Development & Heritage Standing Committee Meeting Agenda

Date: Monday, May 4, 2026

7.1. Rezoning - 3694-3738 Howard Avenue - Z-003/26 ZNG/7355 - Ward 9 (**S 23/2026**)
Author: Adam Szymczak, Senior Planner - Development

TOTAL	18 1-BEDROOM	70 2-BEDROOM	4 3-BEDROOM
	= 90 UNITS

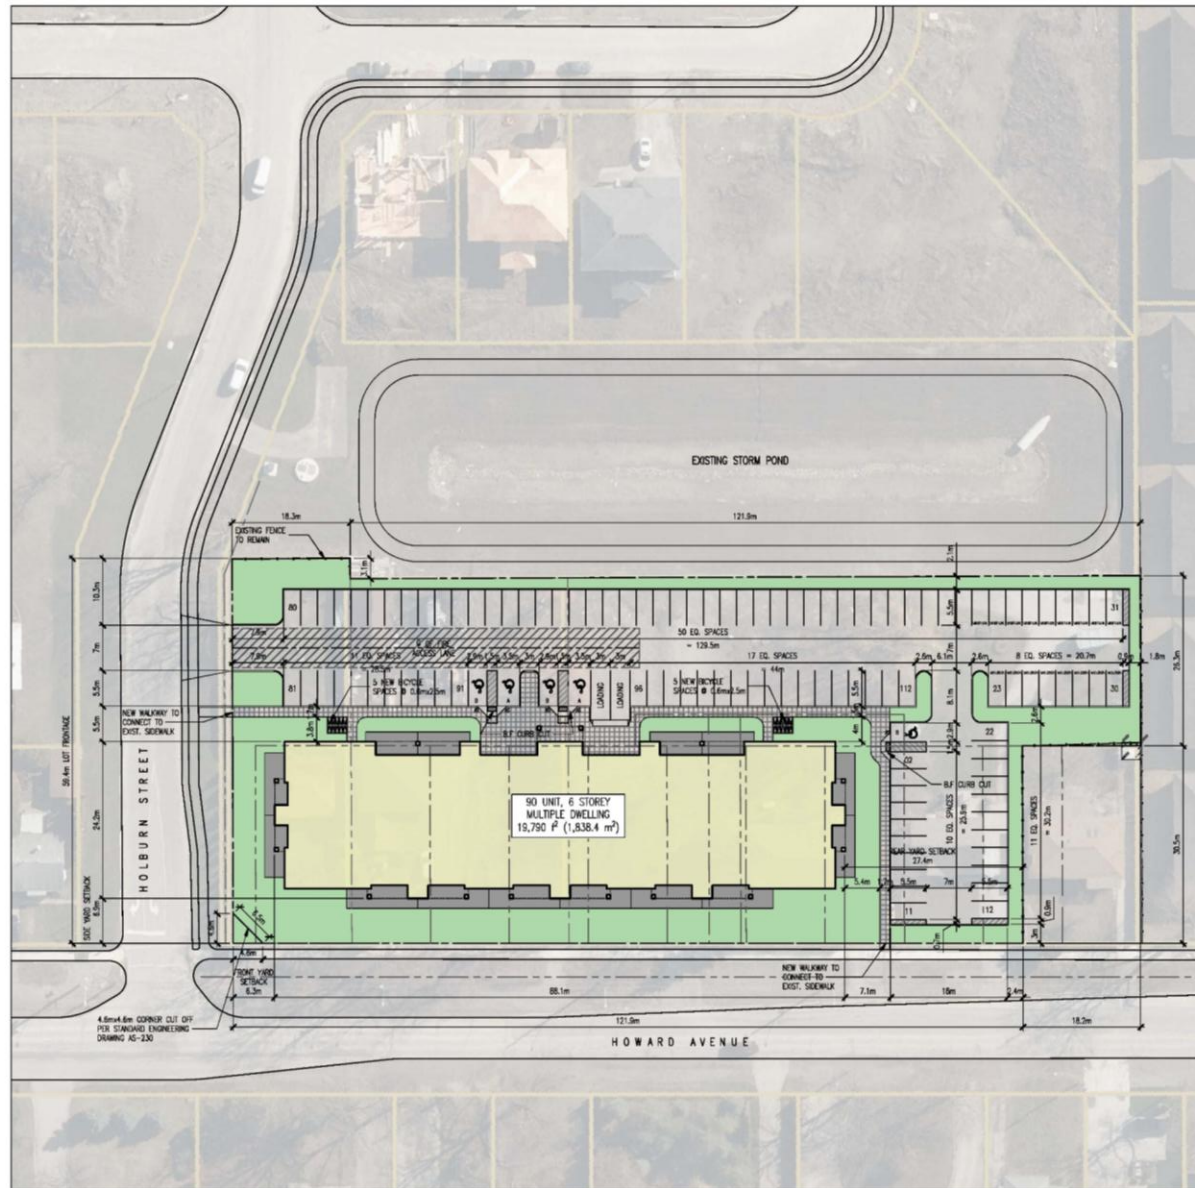
- Modify drawings to include corner cut-off as per Standard Engineering Drawing AS-230.

Corner Cut-Off: The owner(s) agrees, prior to the issuance of a construction permit, to gratuitously convey a 4.6 m x 4.6 m (15' x 15'), corner cut-off at the intersection of Howard Ave and Holburn St in accordance with City of Windsor Standard Drawing AS-230.

HURON CHURCH ROAD

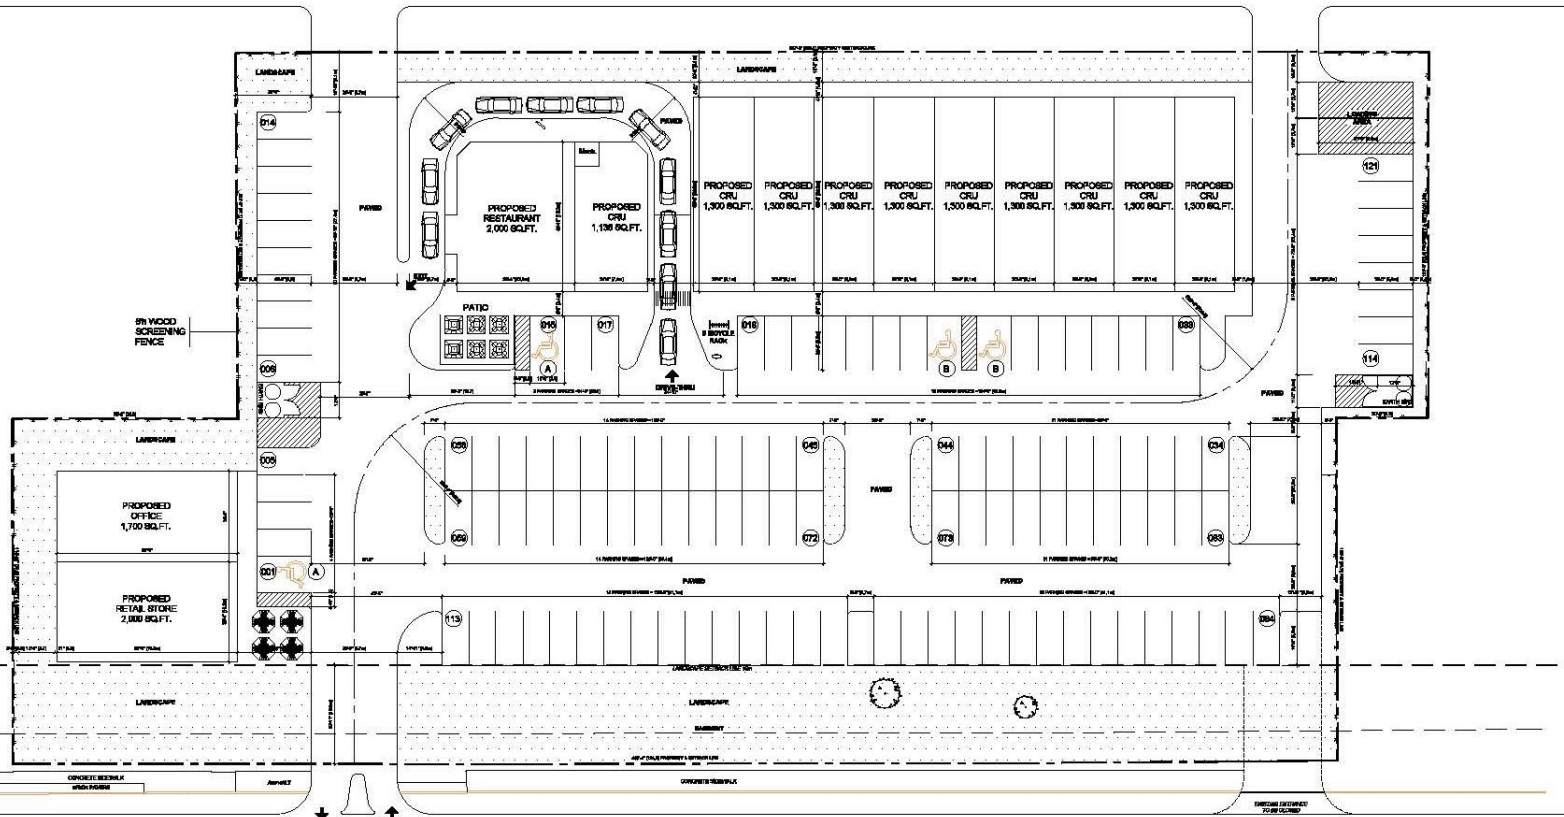
1. **Driveway Approaches** – Do not conform to City of Windsor Standards, which must be constructed with straight flares and no raised curbs within the right-of-way.
 - Modify as per Standard Engineering Drawing AS-204.
 - Porkchop as per AS-547
 - Official plan amendment required for access on Huron Church Road.

Figure 5: Proposed decrease of the SIDE LOT LINE to 0.6 m.

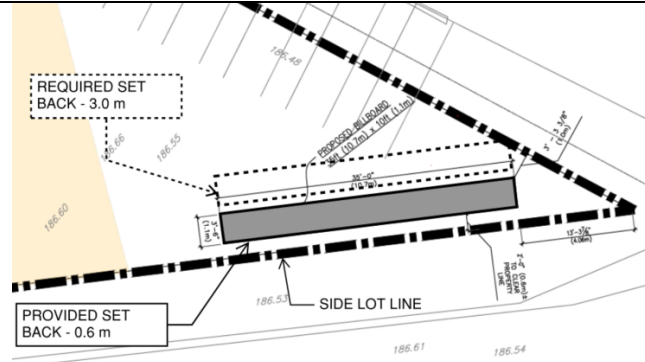
ii. Be ERECTED within 3.0 m of a SIDE LOT LINE;

Figure 6: Six (6) existing billboard ground signs are located within the 200.0 m radius of the proposed Electronic Change Copy Ground Billboard.

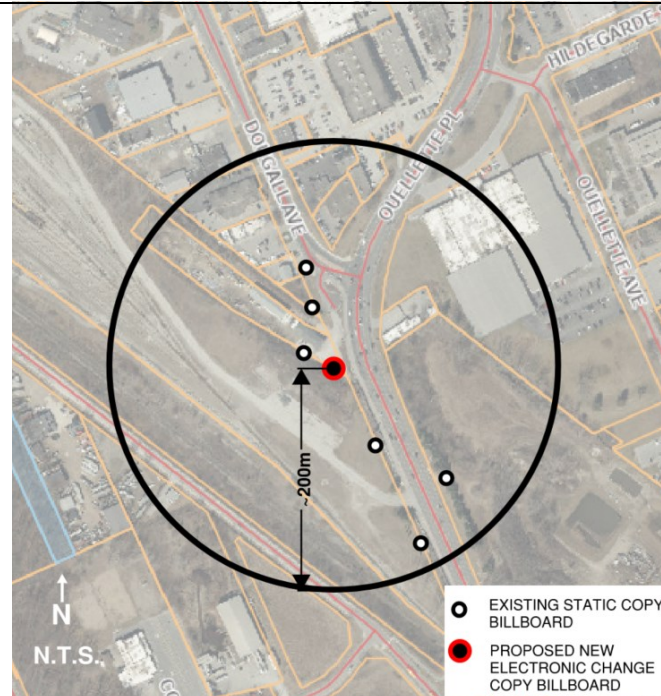
i. Be ERECTED within a 200.0 m radius of any POSTER BILLBOARD SIGN that is a GROUND SIGN or WALL SIGN;

REV. NO. S1

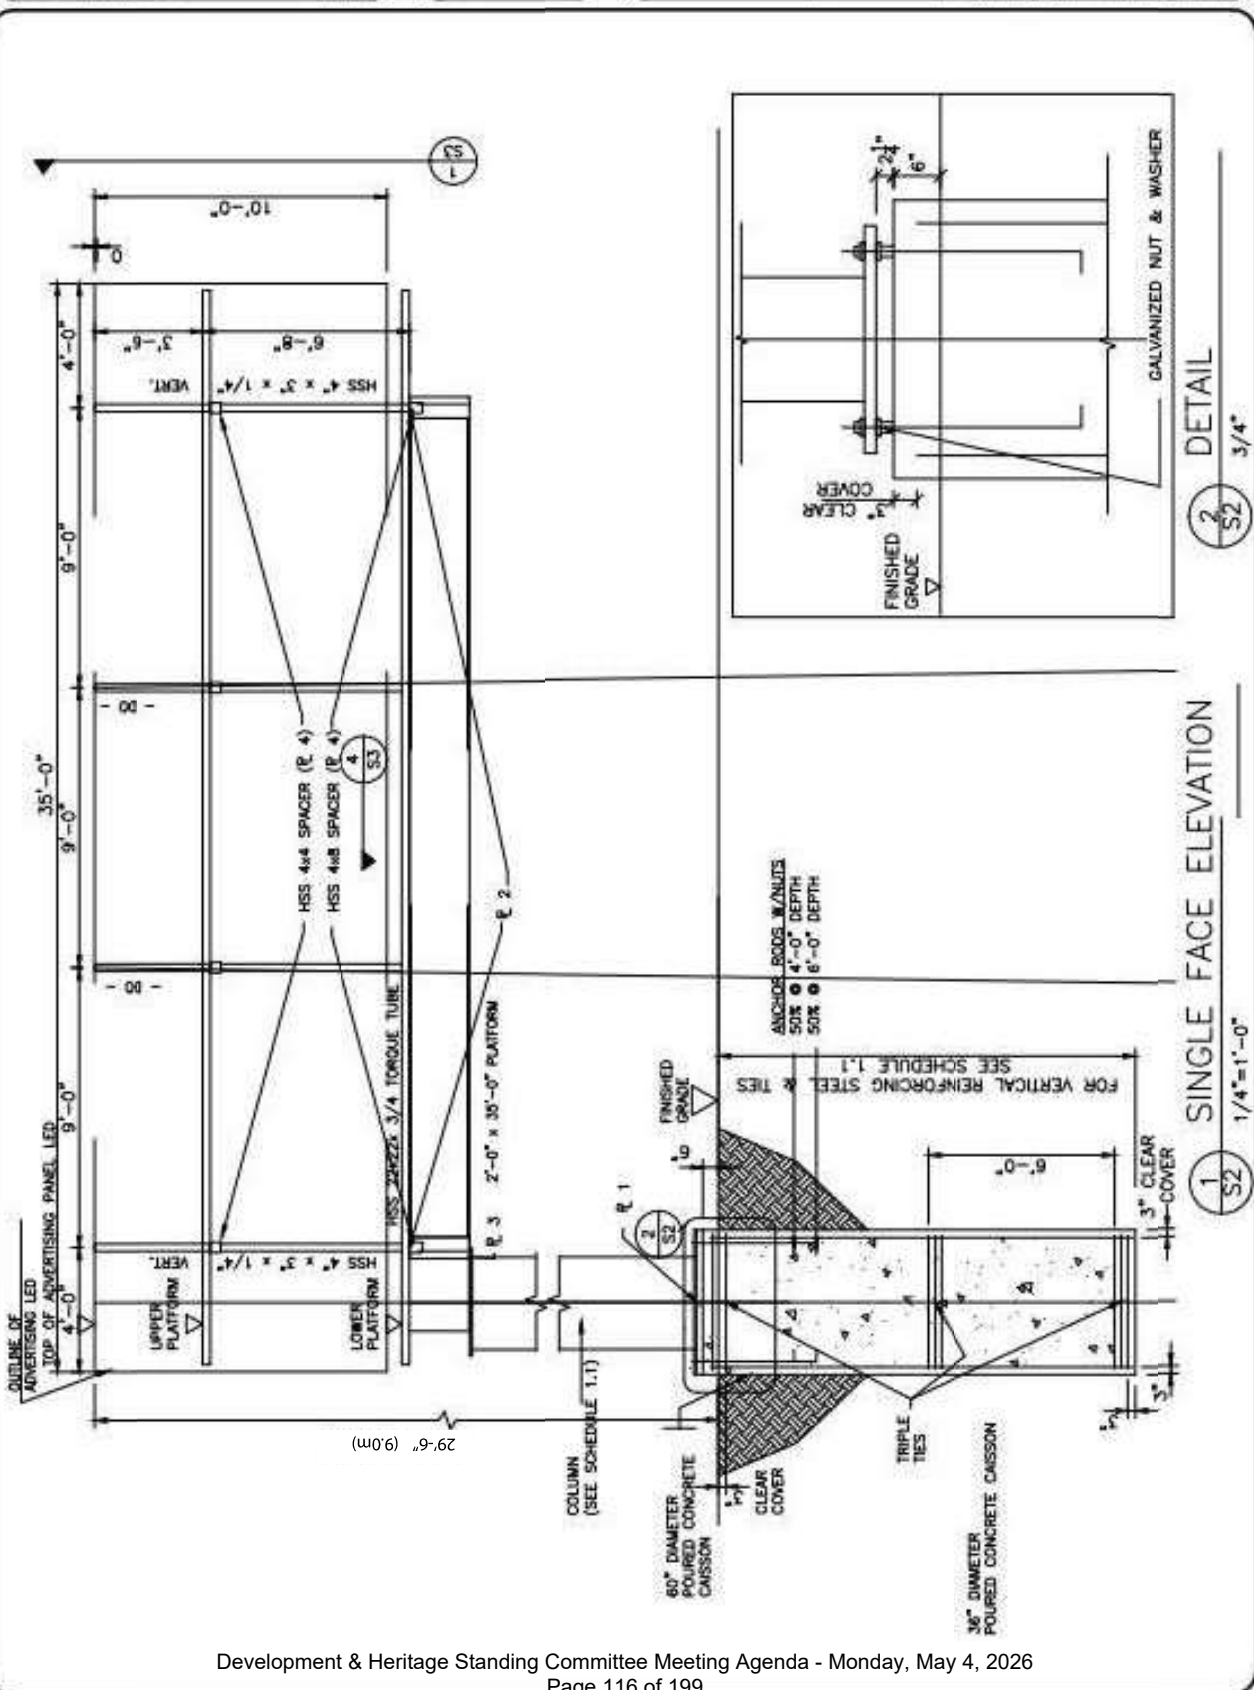
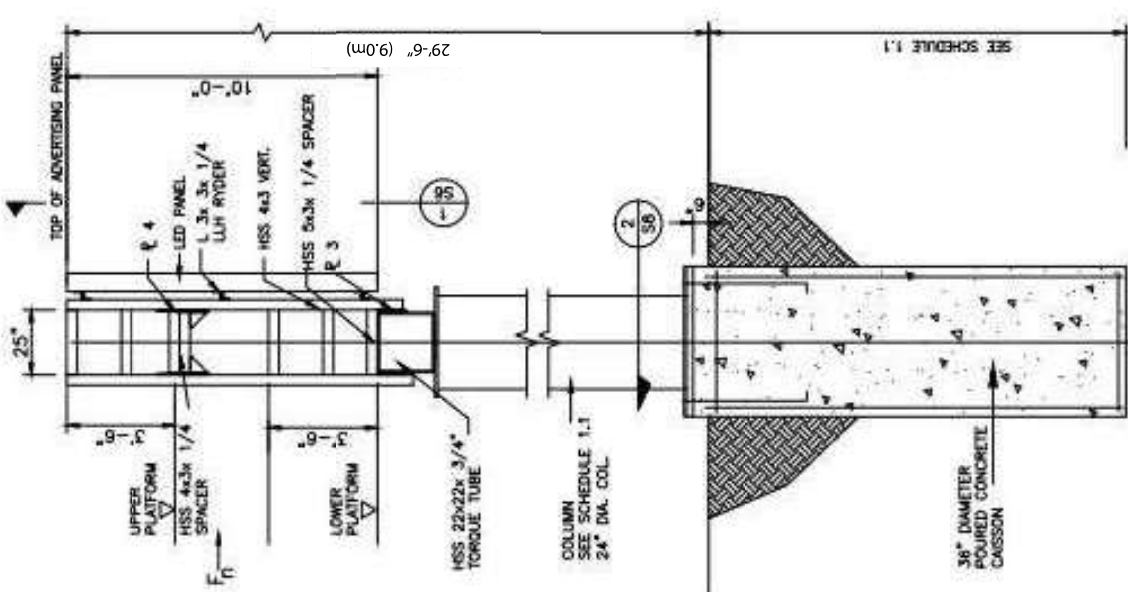
1. Drawing S1 - Table A - Depth of caisson changed from 21'- 0" to 25'-6";
2. Drawing S1 - Table A - Vertical reinforcing steel changed from 16-30M to 16-35M;
3. Drawing S1 - Table A - Number of ties changed from 22-15M to 22-15M plus 3x3=9-15M;
4. Drawing S1 - Structural Note #20 - "Verify caisson design with a Soil's Engineers test" - this is partly due to the depth of the caisson;
5. Drawings S2, S4, S7 and S10 - the horizontal locations of vertical members have been changed by 6 inches to allow for a smaller overhang at the end;
6. Drawing S8 - Detail 2 - Plate 1 - Column base plate - additional note on the 2" diameter A325 anchor rods "with bottom washer and nuts" for clarity;
7. Drawing S9 - Detail 1 - the torque tube is shown raised 3 inches (75mm) to allow for adjustment for nuts and bolts on the cap plate.
